Response to Submissions – Toga Central – SSD-33258337

Thank you for your correspondence dated 10 January 2023 inviting the City of Sydney (the City) to comment on the Response to Submissions (RtS) submitted for the Toga Central development at 2-8A Lee Street, Haymarket.

Figure 2: Copy of Figure 76 from the Heritage Impact Statement

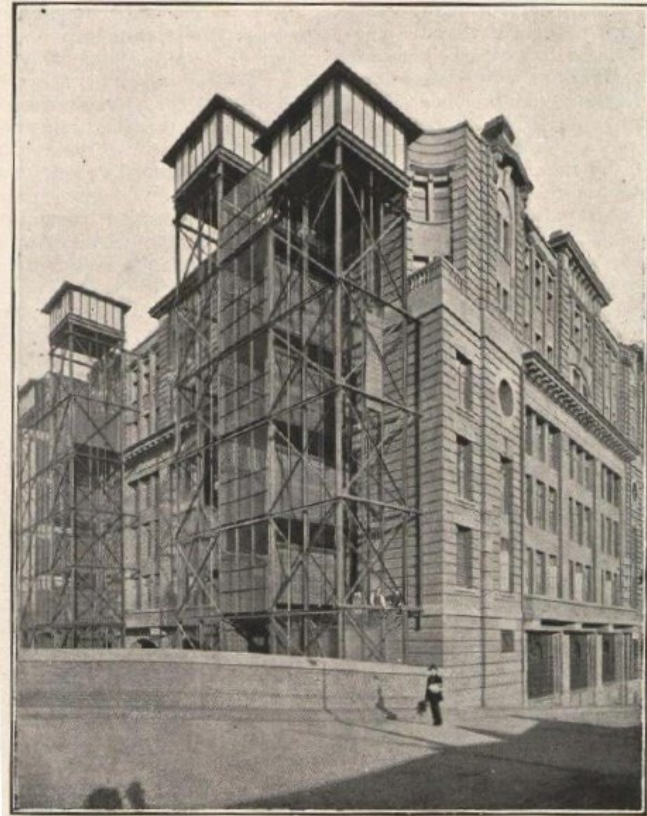
Figure 76 of the Heritage Impact Statement prepared by Urbis provides a historic photo of the former Parcels Post Building with the following caption:

“Architectural Disfigurement, the New Parcels Post Office, at Sydney Railway Station. The above is a glaring example of the inconsistency of Government methods. A public building, having a fine stone façade, costing thousands of pounds, is turned into an eyesore by the addition of shoddy external lift construction” (Source: Building, Vol 17 No 98, 12 October 1915, p59).

The proposed development results in a similar ‘disfigurement’ of the external facades of the building, as the reconstruction of brick and sandstone is again proposed to be demolished to allow for new lifts. The proposed tower intrudes into the existing volume and requires 60% of its demolition. As a result, the physical and visual impact to the heritage item is extreme and negative (See Figures 3 and 4 below).

Overall, the City maintains our previous position in that we do not support the extent of demolition to the eastern façade and recommend amending the design to allow for the retention of the south-eastern corner of the building and to be more sympathetic to the existing building, which is of exceptional heritage significance.
